Office Action Summary

10/773,614

BRENNAN ET AL.

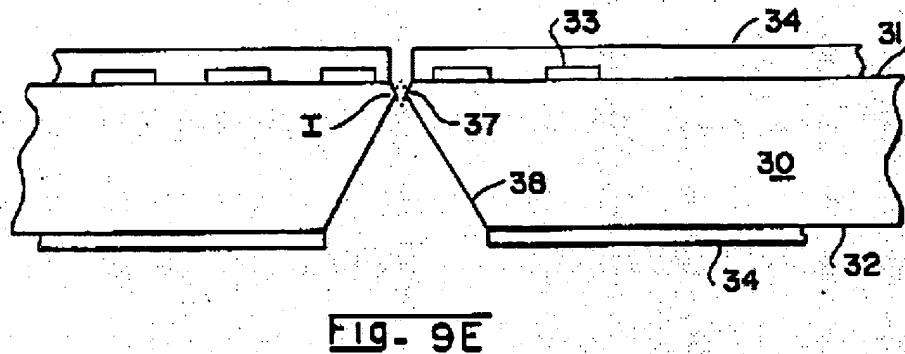
Applicants argue that “the prior art fails to teach or suggest joining the first and second adjacent sides of the IC, die the chamfer having upper surface which is angled relative to the first and second adjacent sides...”

In response to applicants argument, it is respectfully submitted that Drake et al. '821 disclose all the claimed limitations including the limitation *joining the first and second adjacent sides of the IC, die the chamfer having upper surface which is angled relative to the first and second adjacent sides.*

As depicted on Fig. 9E above, the chamfer (37) (i.e., upper surface) the bottom groove (38) (i.e., the bottom surface) are joined (i.e., the top and bottom sides of the IC die connected through the via and detached). In addition the chamfer 37 is angled relative to the front and the back side of the IC chip.

Therefore, the rejection of claims 1-24 under 35 U.S.C. 102 is deemed proper.
